2nd Addendum to the Environmental Impact Report on the
Natomas Levee Improvement Program
Landside Improvements Project—Phase 2 Project

State Clearinghouse # 2007062016

SECOND ADDENDUM TO THE PHASE 2 LANDSIDE EIR

Construction Plans for Reclamation District 1000 Pumping Plant No. 4

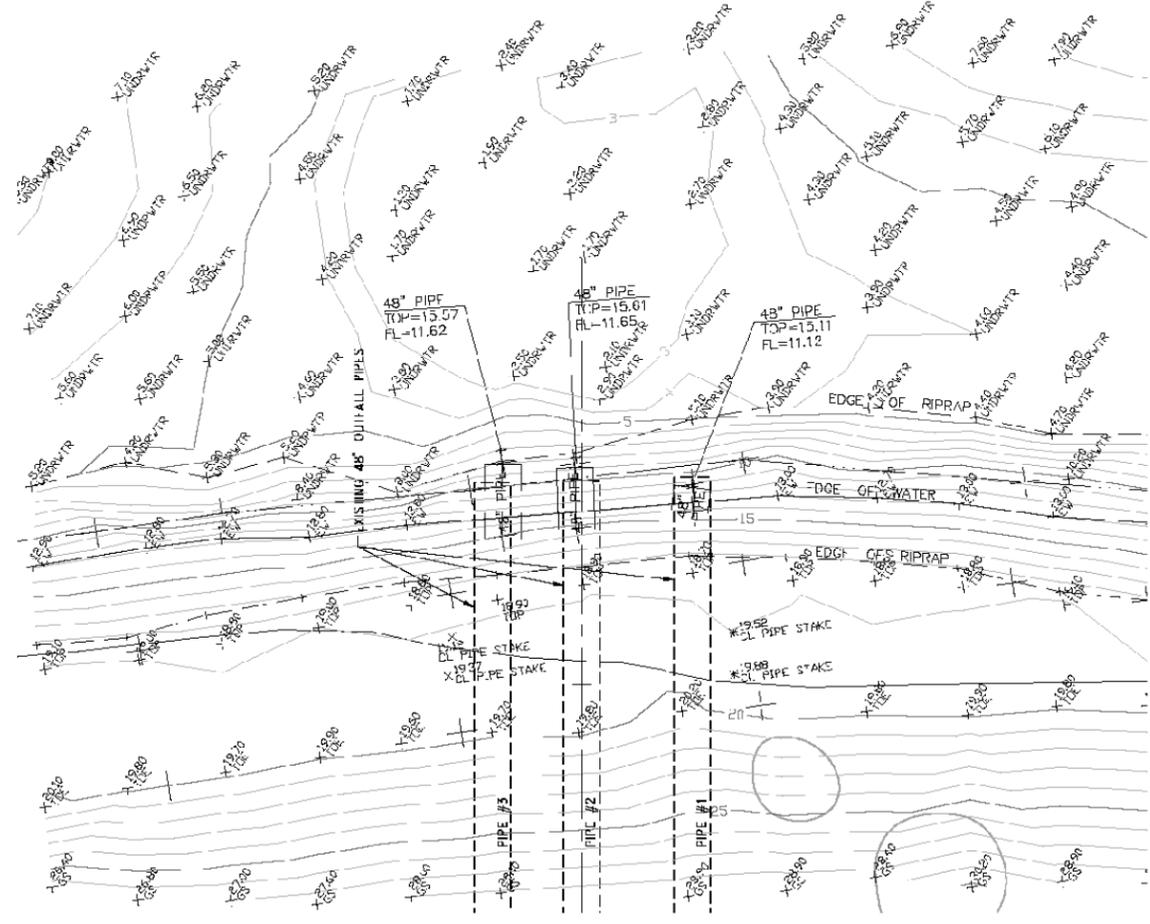
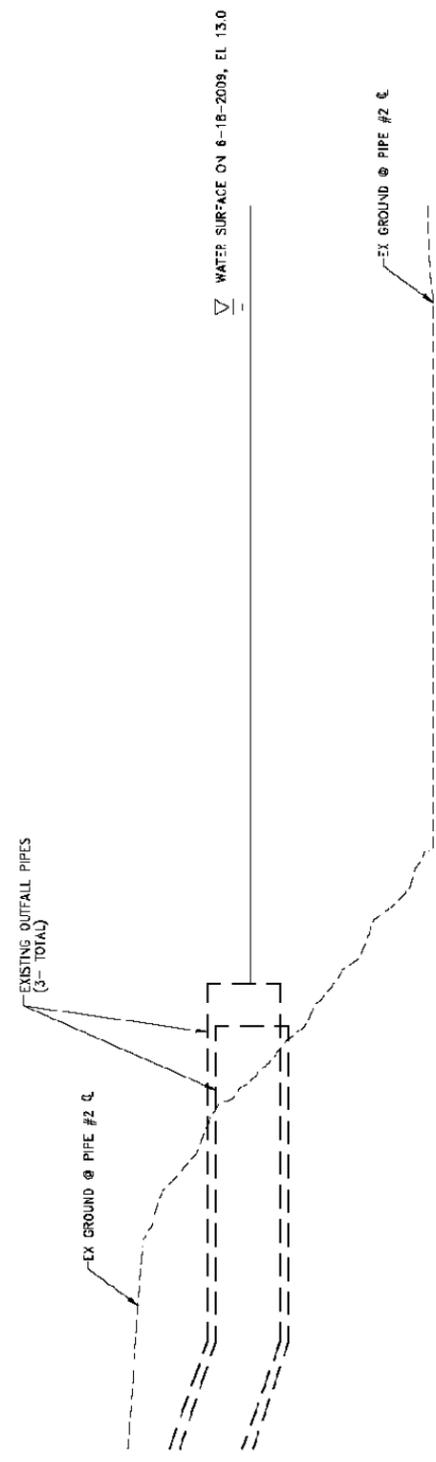
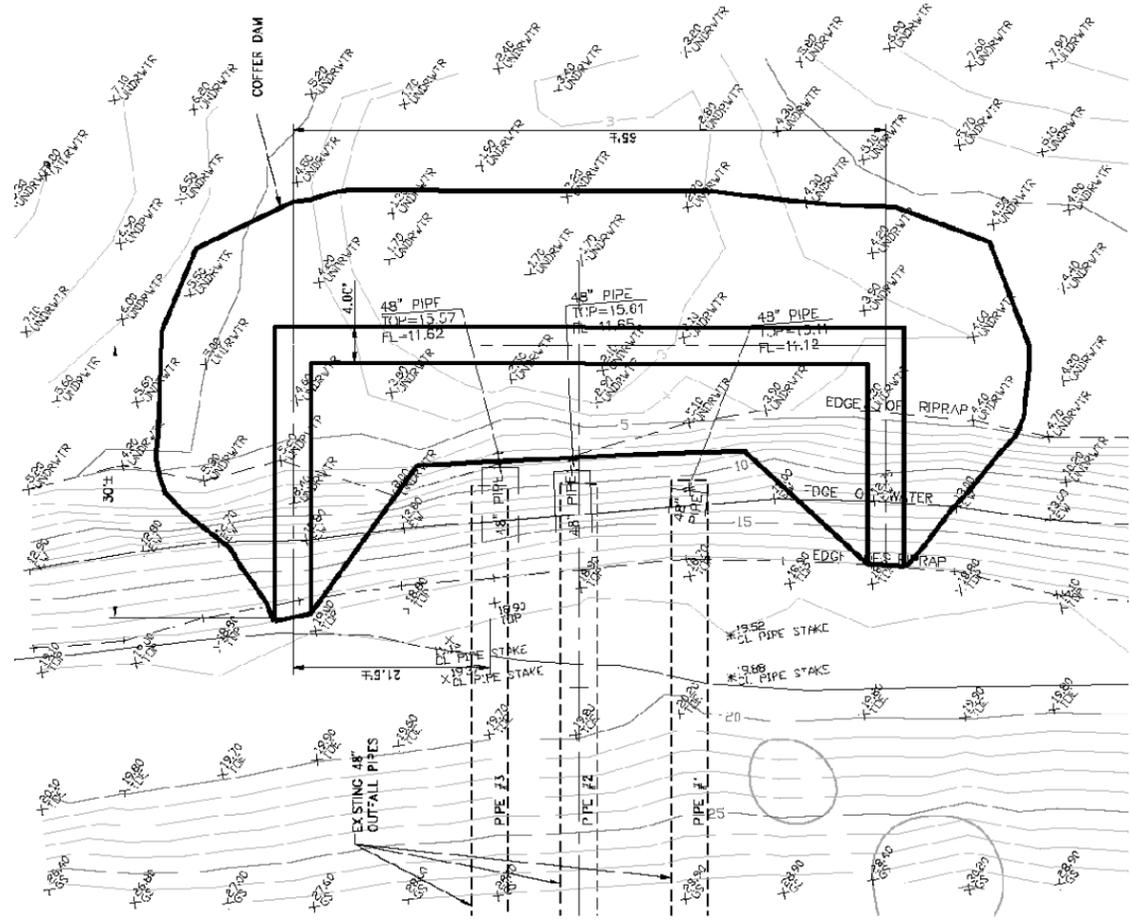
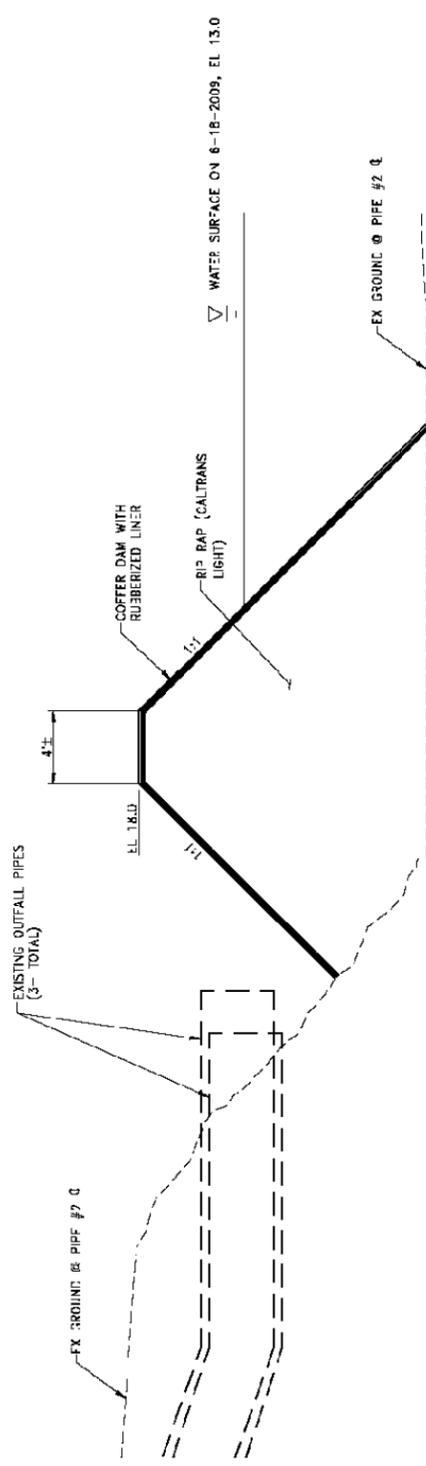
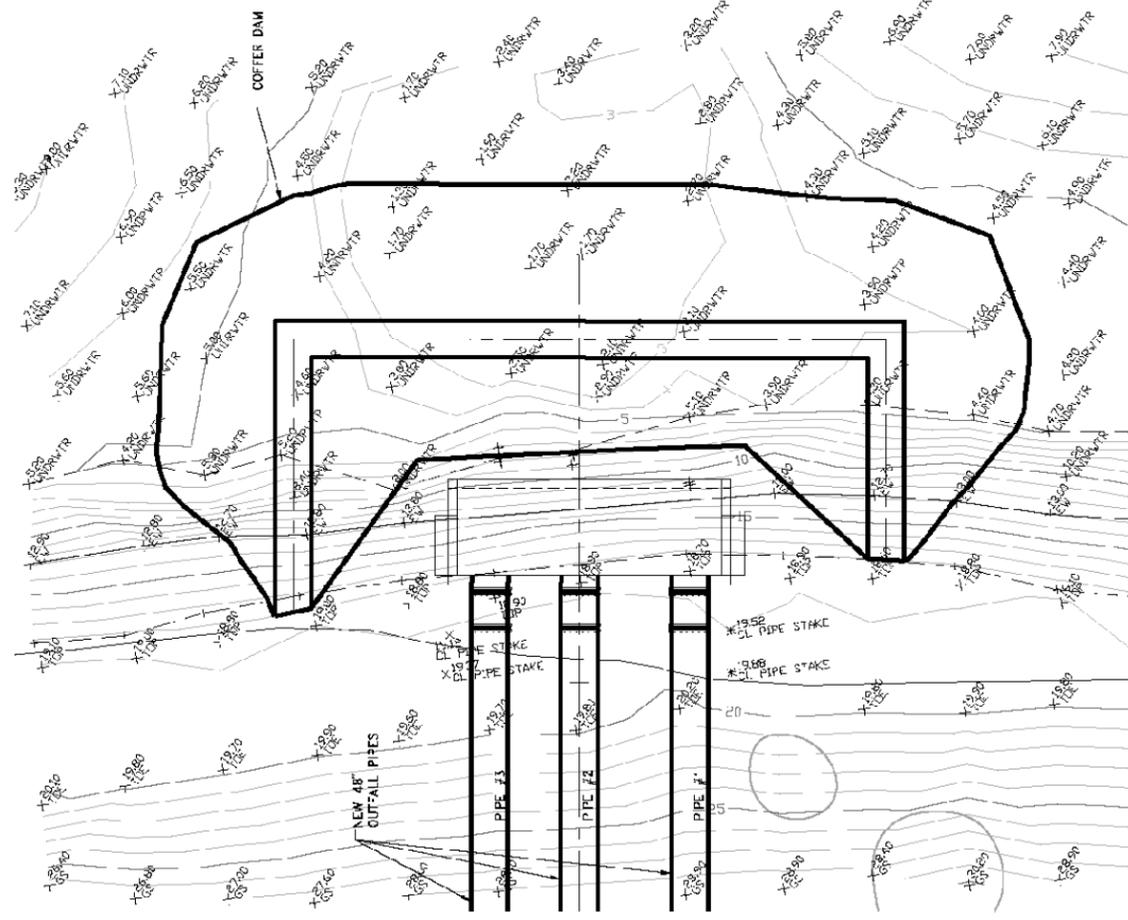
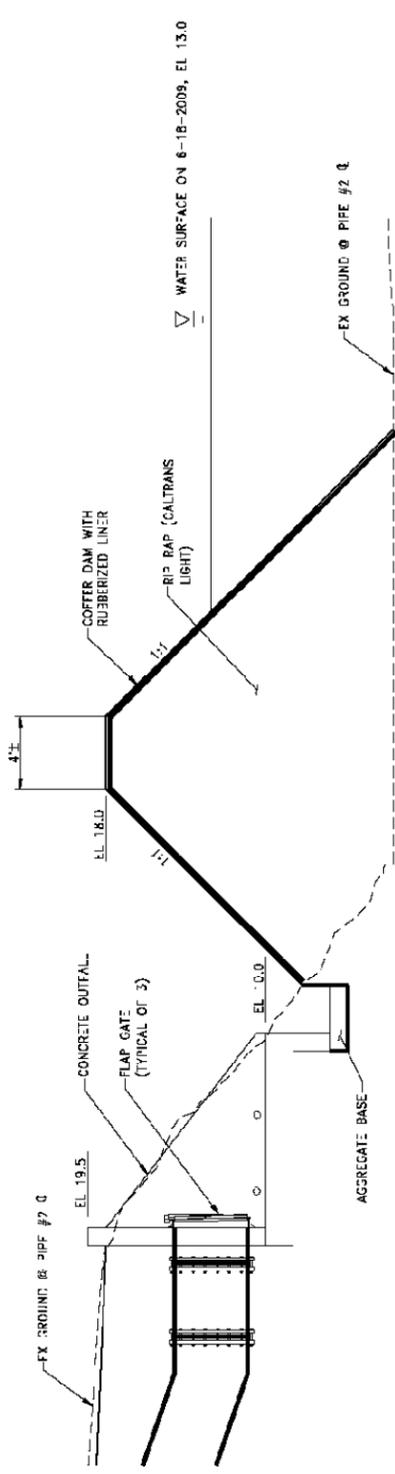
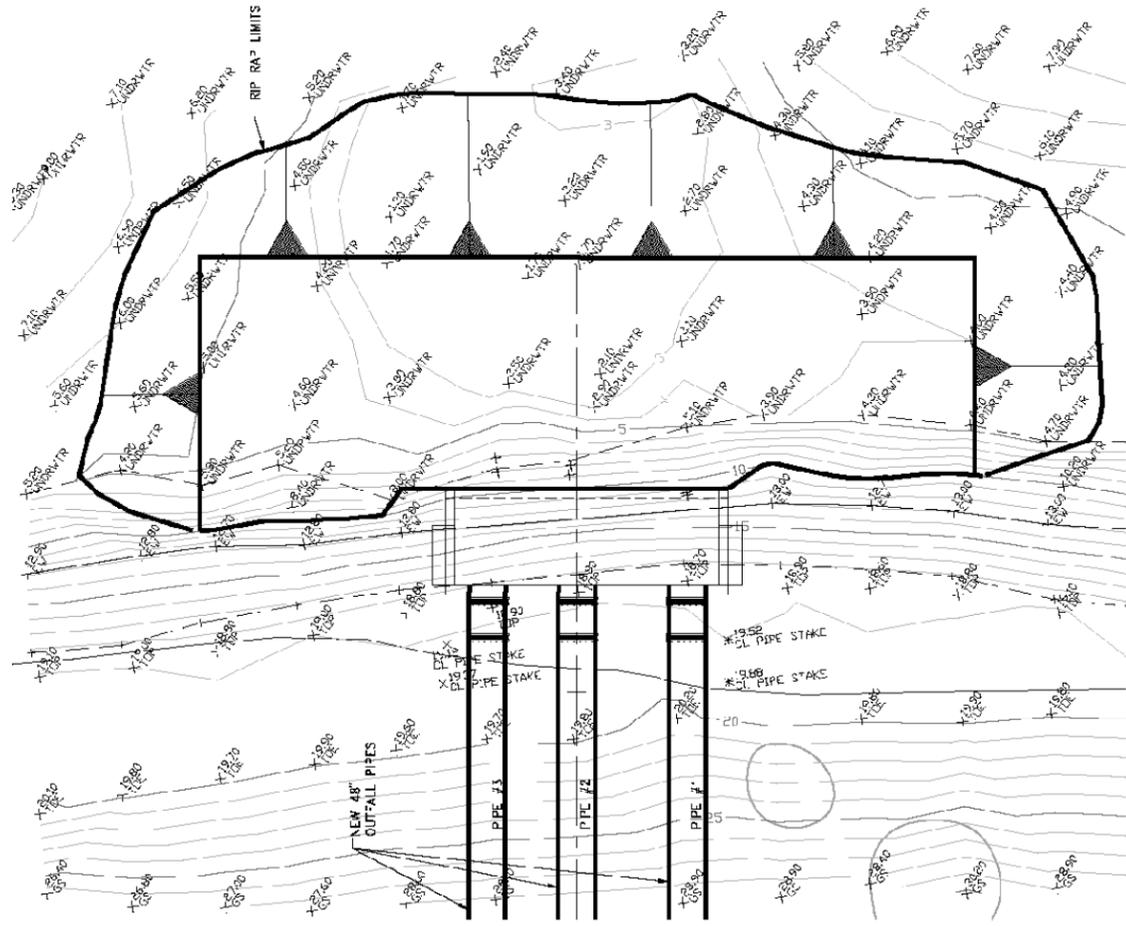
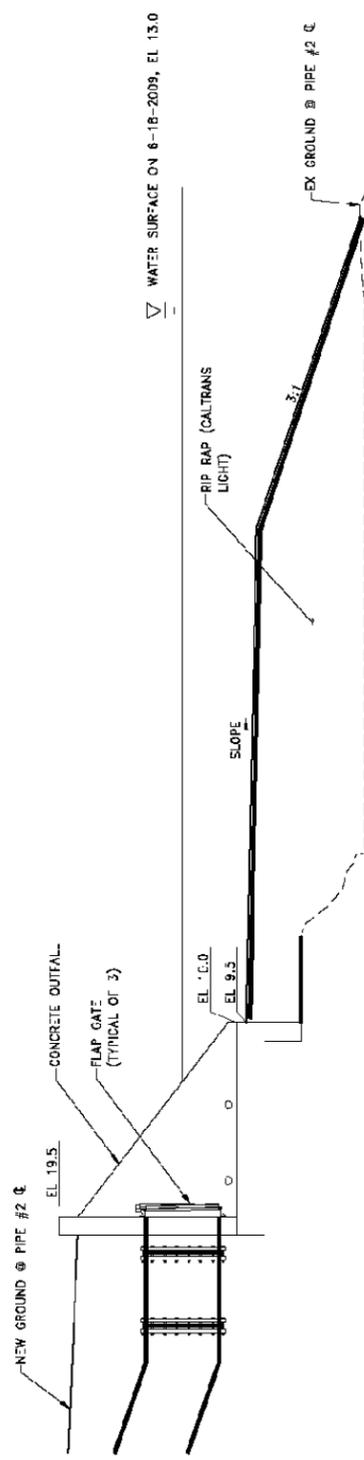
RD 1000 Pumping Plant No. 4, located along the NCC south levee, pumps water from the RD 1000 North Drain into the NCC. To raise the outfall elevation at RD 1000 Pumping Plant No. 4 above the 200-year flood elevation and reconstruct the outfall pipes and outfall structure at the location where the pipes enter the NCC, as identified in the 2007 Landside EIR, the portion of the NCC immediately surrounding the outfall must be dewatered. Dewatering the area requires that SAFCA construct a cofferdam in a U shape surrounding the outfall and connecting with the waterside bank of the NCC south levee at RD 1000 Pumping Plant No. 4 (**Plate 1**). Based on the typical water levels in the NCC at the time this work would occur, SAFCA anticipates that the cofferdam would be constructed of rock riprap. The sequencing of construction of the outfall and cofferdam is shown in **Appendix A**.

The construction contractor would construct a rock cofferdam composed of angular washed rock and place the rock so that it binds with the underlying rock already in the channel and creates a stable configuration. The cofferdam would prevent water from entering the work site while allowing water to flow around the work zone (the cofferdam would not completely obstruct the channel). The shape would resemble a half-circle or U shape extending from the waterside slope of the NCC south levee into the channel. The rock would be placed by using an excavator with a bucket and dipping the filled bucket below the water surface and spilling the rock below the water surface so that rock freefall is minimized. After the rock has been placed, the contractor would place a thin layer (less than about 6 inches thick) of three-quarter- to 1½-inch washed crushed rock over the streamside surface of the cofferdam. This crushed rock would provide a relatively smooth surface over which the contractor would place a rubberized liner that would form the water barrier of the cofferdam, minimizing the potential for water leakage and the possible occurrence of a silt plume from construction within the contained area.

After the area inside the cofferdam is dewatered, the foundation area of the outfall structure would be excavated. During construction of the new outfall structure, additional pumping would likely be required to maintain the lowered water elevation within the cofferdam. This discharge water would be pumped over the levee for proper disposal on the landside of the NCC south levee or directly into the NCC as described above. The cofferdam would be in place for approximately 3 months.

During cofferdam removal, the contractor would use some of the rock from the cofferdam to fill in the area around the Pumping Plant No. 4 discharge outfall structure. After the initial placement of rock is complete, water would be pumped into the cofferdam area to equalize the water pressure on the rubberized liner. The liner would then be removed. The contractor would then remove the remaining rock that is not used for the new plant outfall apron.
